Item ID: D212-664-101TRN

Item Name: Crosstube Turning Detail

DART AEROSPACE LTD		Work Order:	92857
Description: Crosstube Assembly (205/212/412 High Fwd)		Part Number:	D212-664-141
Inspection Dwg: D212-664-141 Rev: D		Page 1 of 2

DRAWING NO. D212-664-141	TITLE XTUBE ASSY (205/212/412 HI FWD)	REV. D	DART AEROSPACE LTD ENGINEERING ORDER		D.E.O. NO. D212-664-141-D-1	SHEET NO. SHEET 1 OF 2	SCALE NTS
DRAWN	CHECKED	MP	MFG. APPR.	RE	APPROVED	MP	DE APPR.
DATE 11.04.07	DATE 11.04.11		DATE 11.04.12		DATE 11/04/12		DATE 11.04.12

D212-664-141/-141B
ASSEMBLY DETAIL

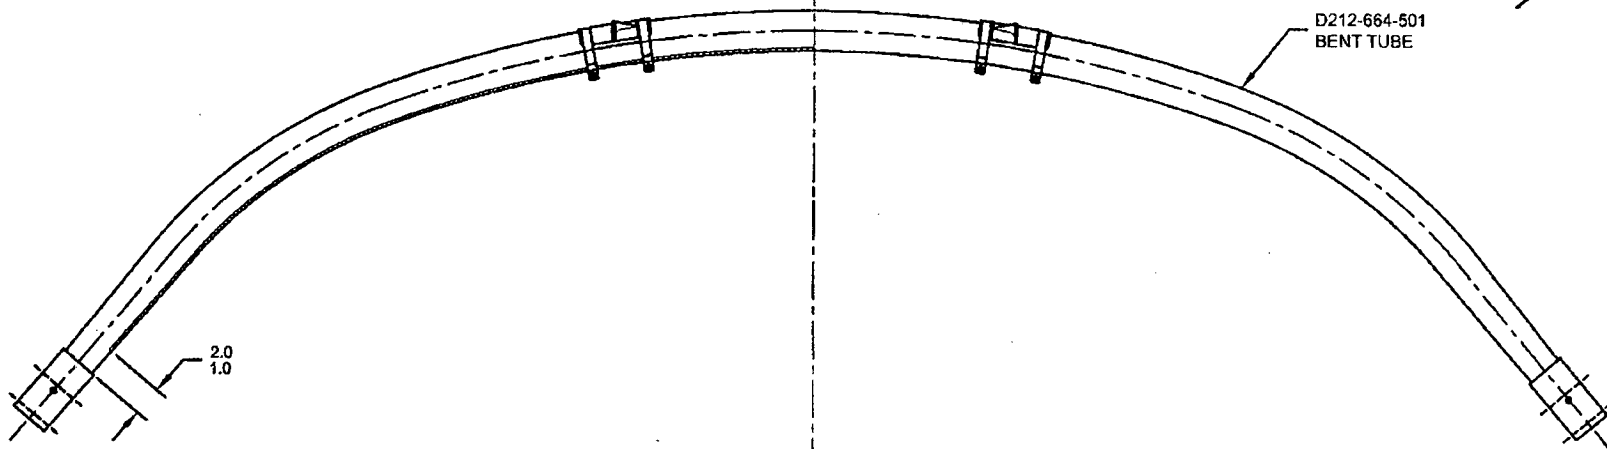
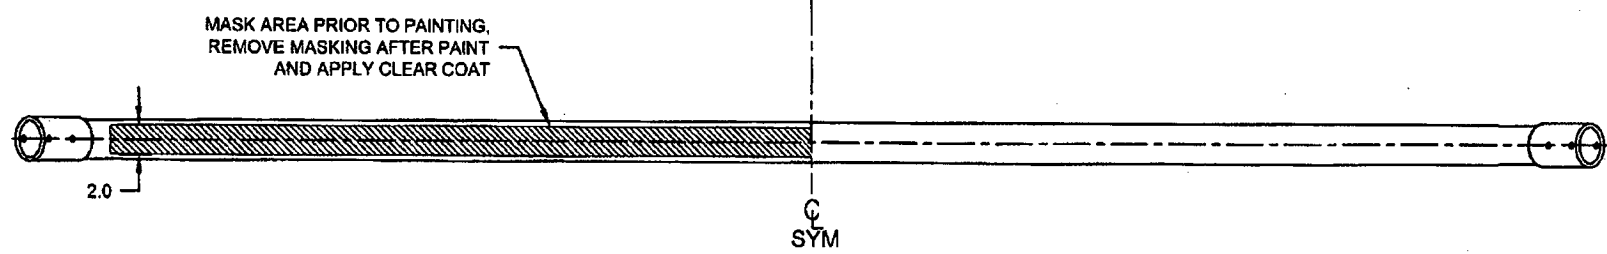
PURPOSE:

ADD AN INSPECTION WINDOW TO UNDERSIDE OF CROSSTUBE.

NOTES 2 OF SHEET 1 IS AMENDED AS FOLLOWS:

- 2) FINISH: CHEMICAL CONVERSION COAT PER DART QSI 005 4.1
PRIME INSIDE AND OUTSIDE PER DART QSI 005 4.2
MASK UNDERSIDE OF CROSSTUBE AS SHOWN (HATCHED AREA) AND
PAINT OUTSIDE PER DART QSI 005 4.2
REMOVE MASKING AND APPLY CLEAR COAT

- 2) FINISH: CHEMICAL CONVERSION COAT PER DART QSI 005 4.1
PRIME INSIDE AND OUTSIDE PER DART QSI 005 4.2
PAINT OUTSIDE PER DART QSI 005 4.2
